RS-14-205

Braidwood Station, Units 1 and 2  
Facility Operating License Nos. NPF-72 and NPF-77  
NRC Docket Nos. STN 50-456 and STN 50-457

Subject: Third Six-Month Status Report in Response to March 12, 2012 Commission Order  
Modifying Licenses with Regard to Requirements for Mitigation Strategies for Beyond-  
Design-Basis External Events (Order Number EA-12-049)

**Third Six-Month Status Report for the Implementation of Order EA-12-049, Order  
Modifying Licenses with Regard to Requirements for Mitigation Strategies for Beyond-  
Design-Basis External Events**

#### Update Mechanical One Line Diagrams

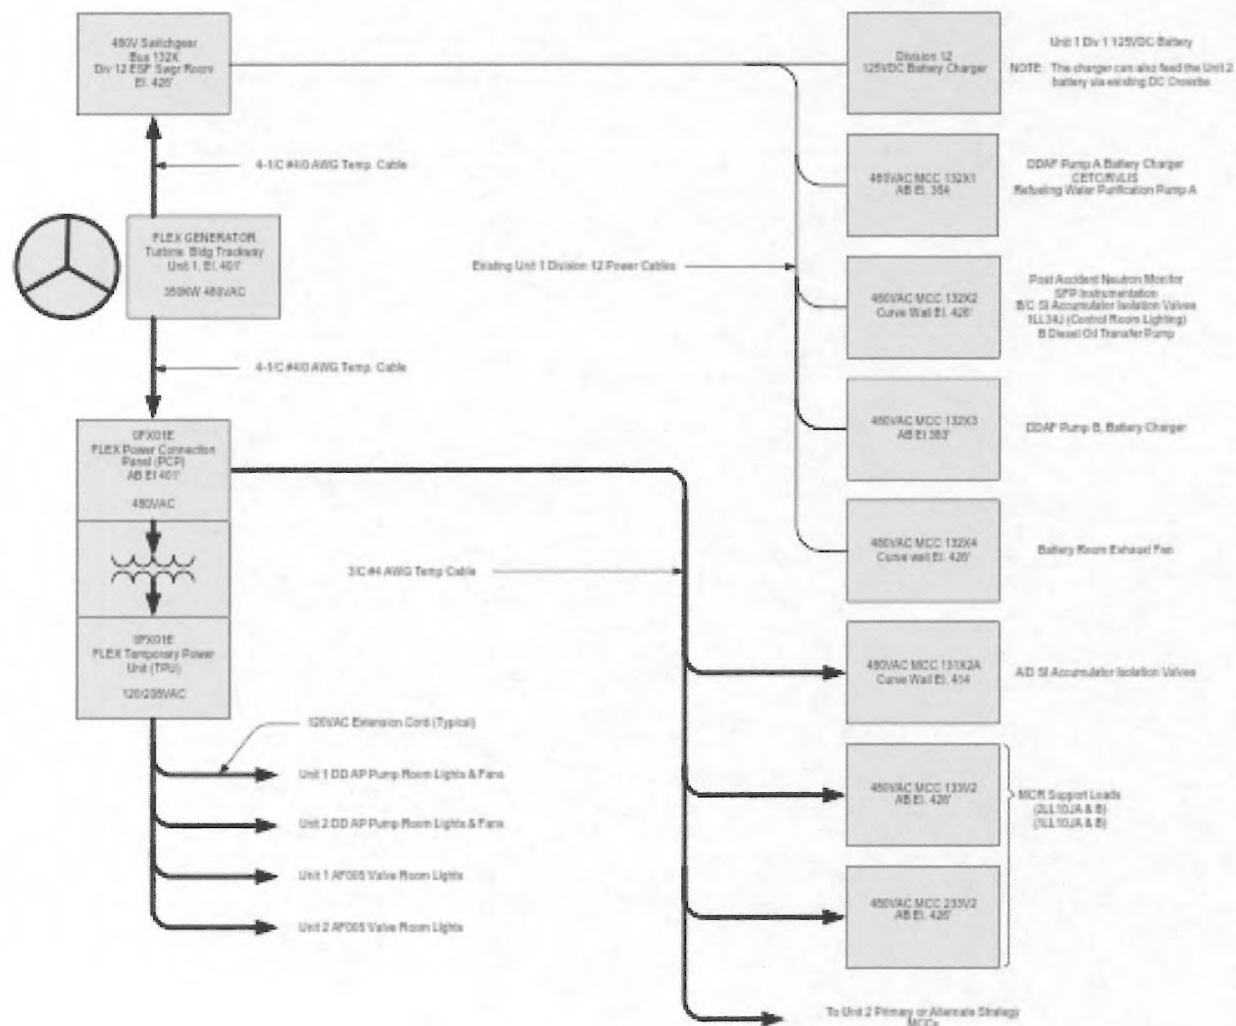
Reason for Change: Updated sketches as a result of refining the site strategy.

Change: Updated sketches are in Attachment 3 of this document
